NAME OF DAM: DALEY DAM  
LOCATION: LOUDOUN COUNTY, VIRGINIA  
INVENTORY NUMBER: VA 10709

PHASE I INSPECTION REPORT  
NATIONAL DAM SAFETY PROGRAM

National Dam Safety Program. Daley  
Dam (Inventory Number VA 10709),  
Potomac River Basin, Loudoun County,  
Virginia. Phase I Inspection Report.

PLATE III

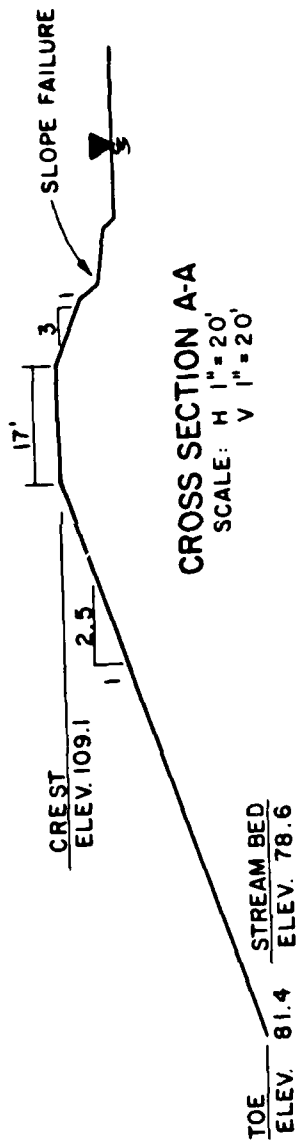
There are no signs of surface cracks, unusual movement, sloughing or misalignment on the crest or downstream face. However, most of the upstream face has experienced slope failure. The failure consists of areas of minor sloughing and areas of large failure surfaces with 4 feet of slip plane exposed. Several footpaths run down both the upstream and downstream faces from the crest. There is minor erosion around the principal spillway outlet pipe. Several animal burrows are located on the downstream face. (See Plate III, Appendix I and Photos No. 2, 3, 4 & 6, Appendix II).

The portions of the upstream slope that have not failed are riprapped. The riprap extends from about 3 feet below pool elevation to about 12 feet up the slope. Evidence of riprap is visible on the slope in the areas of minor sloughing, however, there is no evidence of riprap in the areas of large failure surfaces. Apparently, the whole upstream slope was riprapped but the slope failure carried some of the riprap far enough down the slope, beneath the water surface, to be unobservable (See Plate III, Appendix I).
